MONUMENT RIDGE EAST

EL PASO COUNTY, COLORADO FINAL LANDSCAPE PLAN

TITLE SHEET

LT01

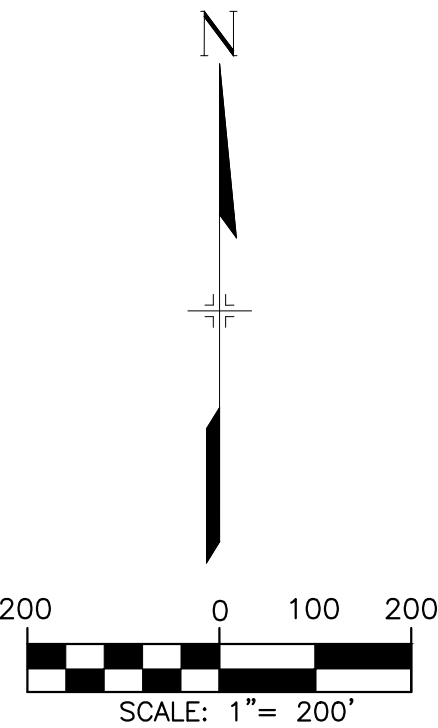
This area of the existing road that is being demo'ed needs to be included on this landscape plan, as it will need to be revegetated.
